**Application for Planning Permission**[click here for case file](#)

Reference	PA/18/01926
Site	255-279 Cambridge Heath Road, London, E2 0EL
Ward	St Peters
Proposal	Demolition of existing buildings on site and redevelopment to provide 189 residential units and 1,676 sqm of flexible commercial floorspace (Use Classes A1, A2, A3, B1 and/or D1) in two buildings ranging from 5 to 15 storeys, along with disabled parking, servicing, cycle parking, public realm and amenity space.
Summary Recommendation	Refuse planning permission
Applicant	Telford Homes PLC
Architect	HTA Design
Case Officer	Christina Gawne
Key dates	<ul style="list-style-type: none">- Application received on 27/07/2018- Application validated on 16/08/2018- Public consultation finished on 21/09/2018

EXECUTIVE SUMMARY

Figure Four: roof plan of north block (play areas shown in red)

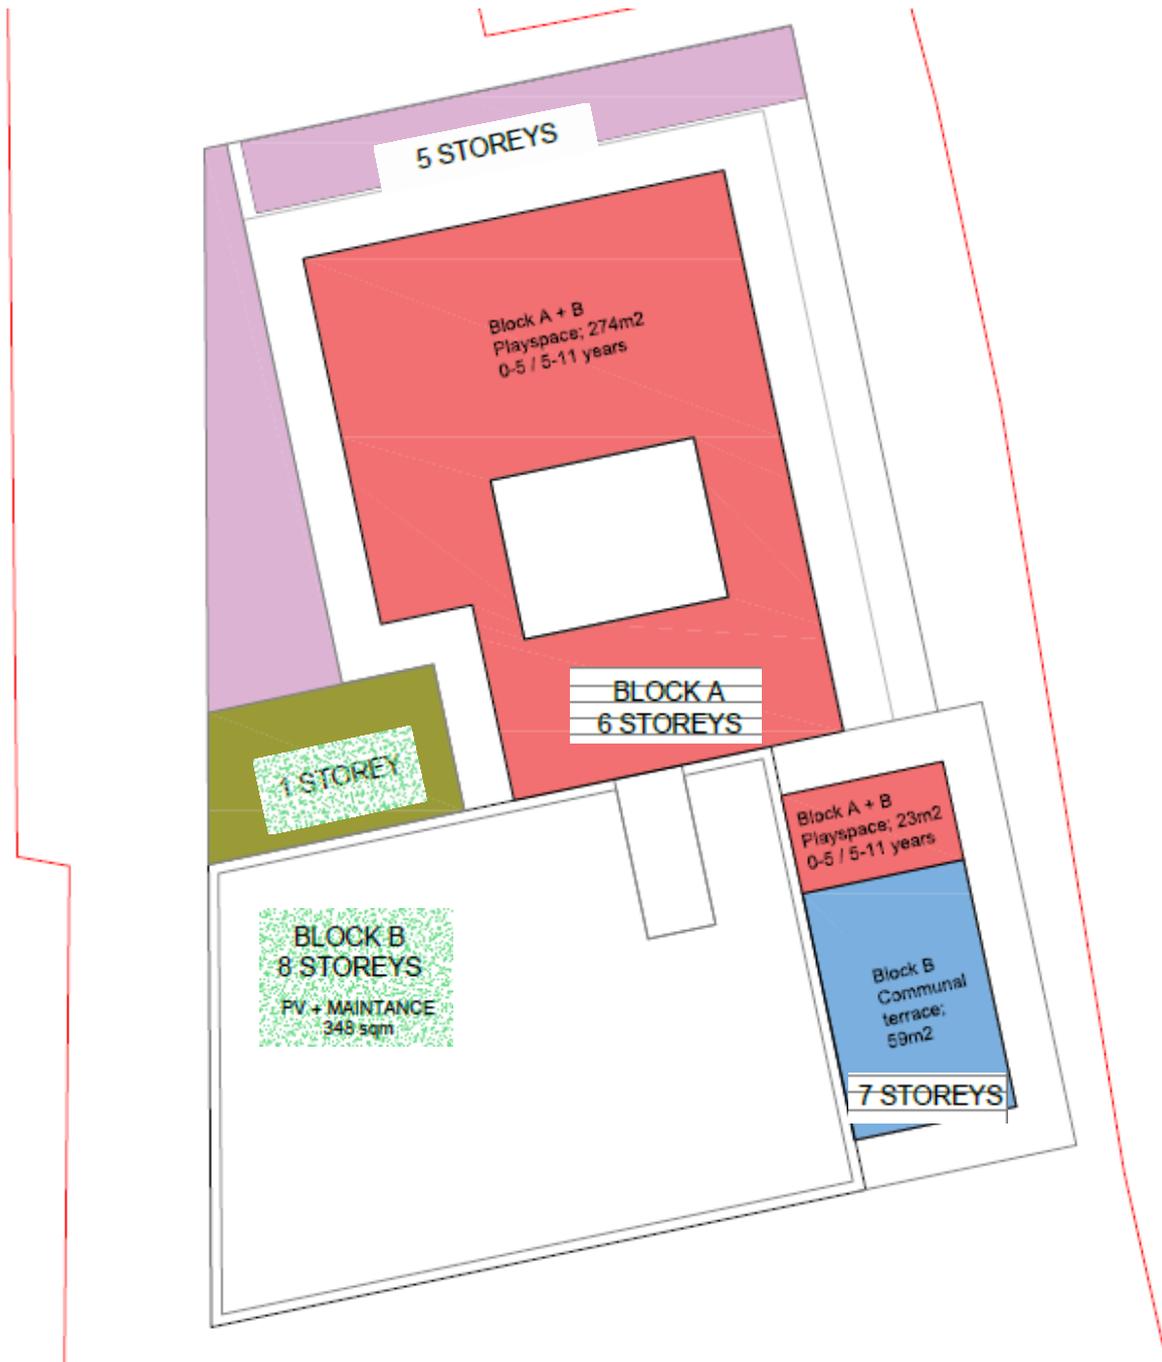
- 7.88 The play spaces are spread across four roof top areas ranging from 1 storey to 8 storeys above ground. The below figures show the locations of the play spaces in relation to the proposed blocks and cores and it is noted that the communal areas will be shared in each building i.e. Core A and B together, Core C and D together. Council has not seen any detail on how service charges for these spaces would work.

Figure 11: Proposed location of oriel windows adjacent to 283 Cambridge Heath Road

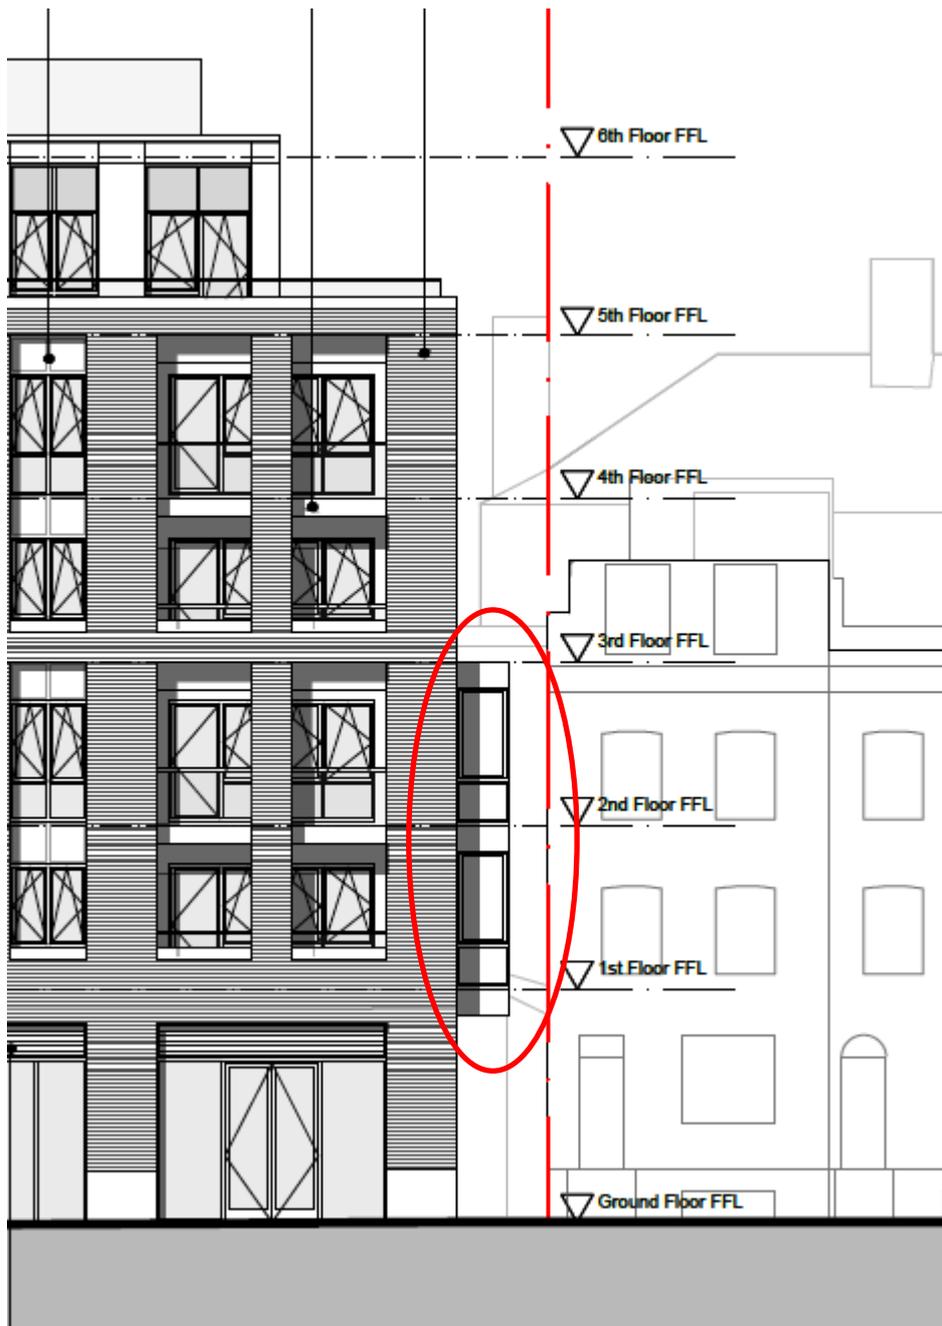
- 7.142 The proposal would have a very limited separation distance between the massing on the site and No. 283 Cambridge Heath Road (north). The introduction of oriel windows set facing No. 283 narrows the separation gap further still and is considered an unsuccessful design feature that fails to address satisfactorily the outlook and daylight issues to habitable room windows within the development facing the flank wall of No 283. The oriel windows do not serve either as a design aid to bridge the different scale of massing proposed on the site to the adjacent terrace and further encroach upon the now reduced space between the buildings by introducing oriel windows (a type of bay window, see below Figure 11). This intervention creates an uncomfortable relationship between the proposed and existing building, that is further emphasised by the height and the additional elements on the roof which creates a block which although marginally taller than the existing building, begins to create an overbearing relationship.

- 7.143 During pre-application, Council accepted the separation distance in previous iterations of the design but these did not include the oriel windows in this location as proposed now. It is considered that the space between the buildings provide an important mediation between the old and new and the increased mass and height. These windows reduce the separation distance between the No.283 and the proposed development. The oriel windows were introduced to address concerns about the outlook from bedroom windows in this location however it reintroduces early concerns about the relationships between the two buildings.

Figure 22: Bethnal Green Gardens south. Proposed.

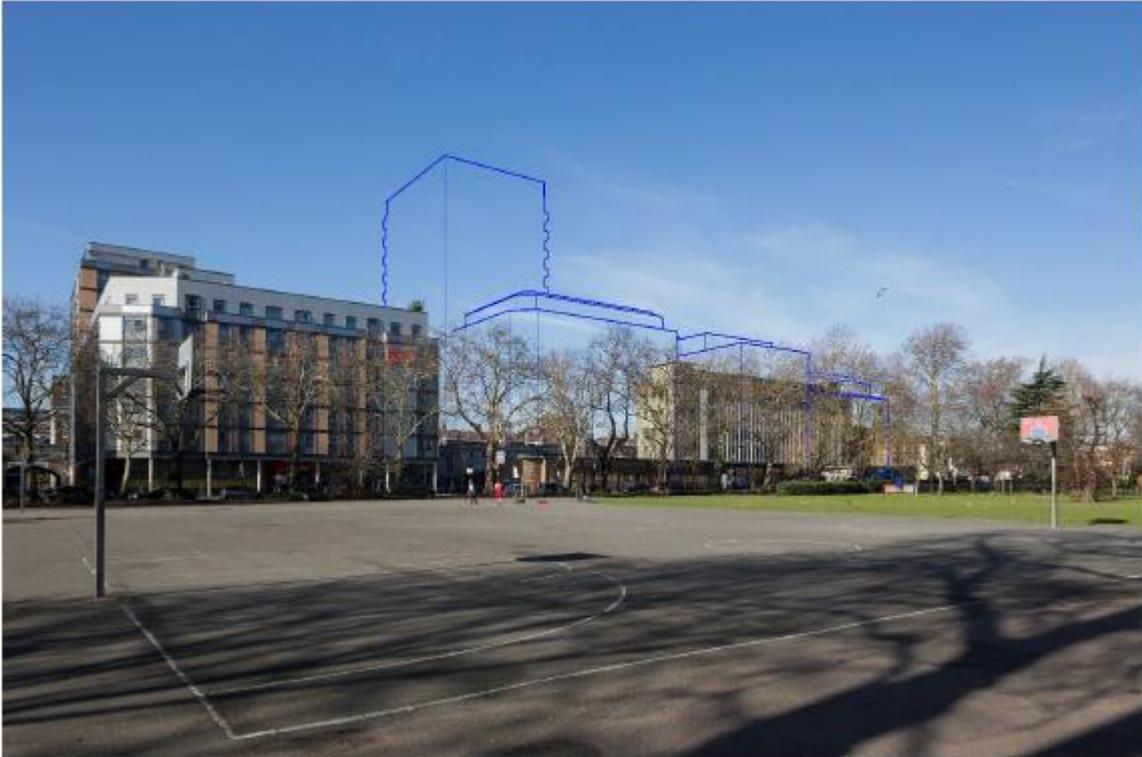
- 7.174 Whilst outside of the Registered Park & Garden of Historic Interest, viewpoint 5 is within the Bethnal Green Conservation Area looking west towards the site. There is a belt of mature trees at the edge of the gardens which in this photograph partially obscure views.

Figure 24: Cambridge Heath Road – south. Proposed.

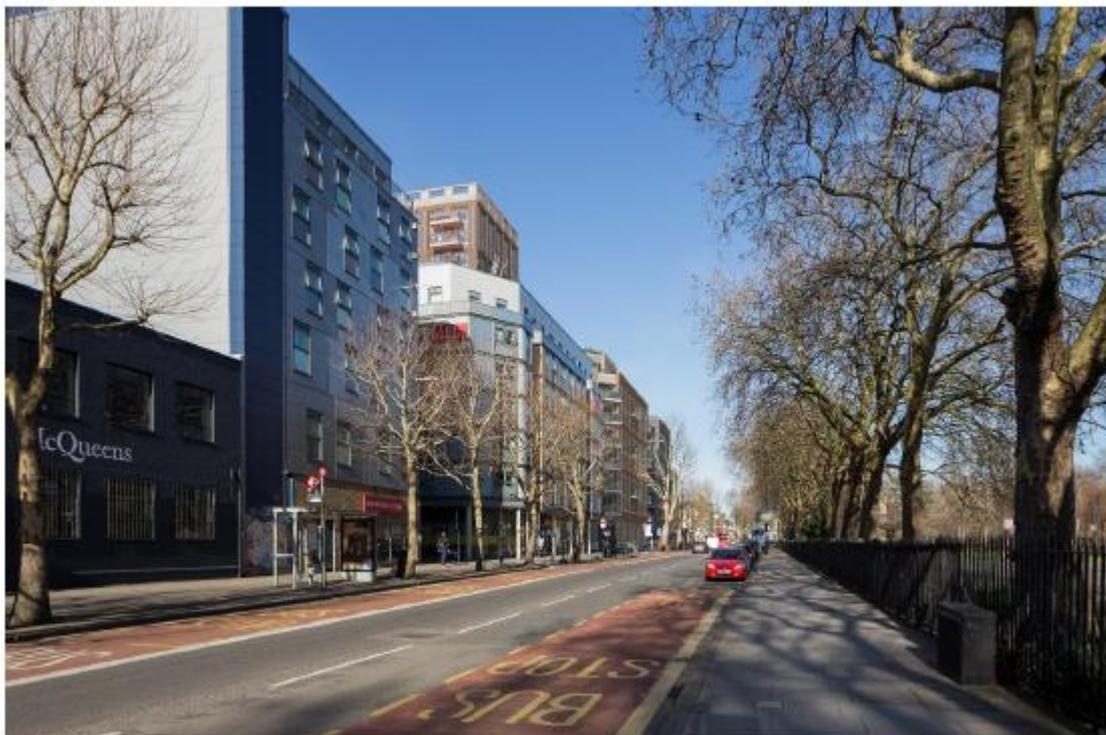
7.177 View 6 is from the south of the site, looking directly north along Cambridge Heath Road towards the site. The Bethnal Green Conservation Area is to the right hand side of the viewpoint. The conservation area extends to the right hand side of the photograph.

Figure 31: floor plans of Blithehale Court

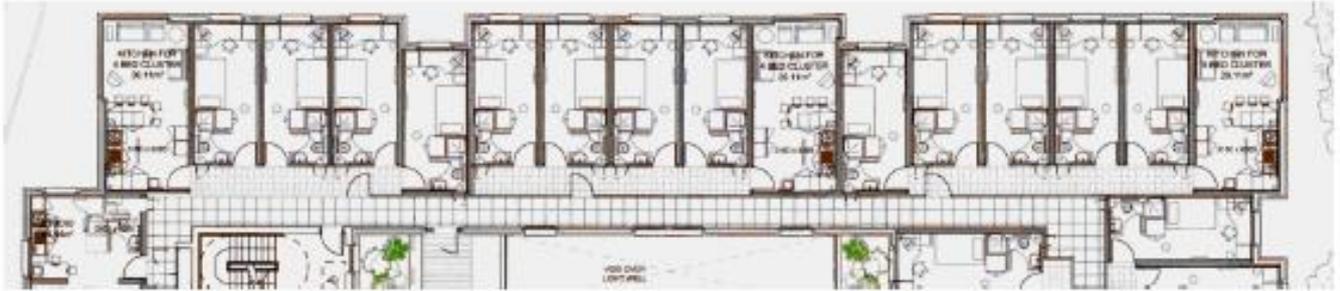
- 7.210 These rooms are currently very well daylight, with VSC values mostly 30%+ and with daylight distribution to almost 100% of most rooms. The effect of the proposed development on this site would be such that 67 out of 173 windows tested (39%) would satisfy the VSC guideline and 39 of 115 rooms (34%) would satisfy the NSL guideline. The windows and rooms tested also include some in the southern wing of the building where they will have a view of the development over the top of the northern wing.

Figure 32: 10-43 Gales Gardens

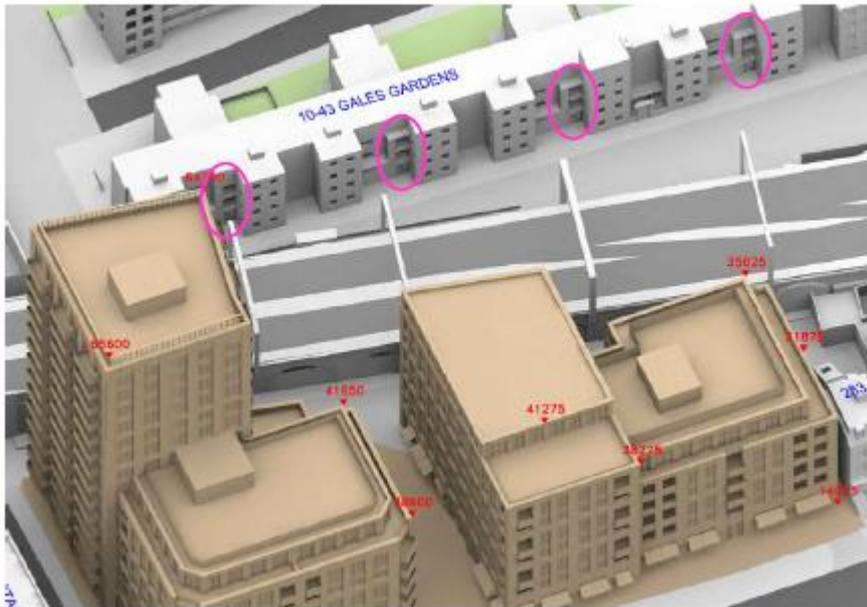
7.223 However, the reason the windows most affected are experiencing moderate and major adverse impacts are more affected is because they are windows in the side return elevations of the projecting wings and have either a restricted view of sky or they are deeply recessed into the façade (ringed in pink in the figure 32 below of the 3D model) and consequently are heavily obstructed and unusually sensitive. Further testing of the latter windows by the applicant show smaller but nonetheless medium impacts. That is partly because the immediately adjacent projecting wings of the neighbour's building are also a factor, as they heavily blinker the view of sky.

7.224 Sunlight impacts are very largely BRE adherent with just three rooms experiencing transgressions. Two of those are with heavily recessed windows and the third is in a projecting wing with a blinkered side window.
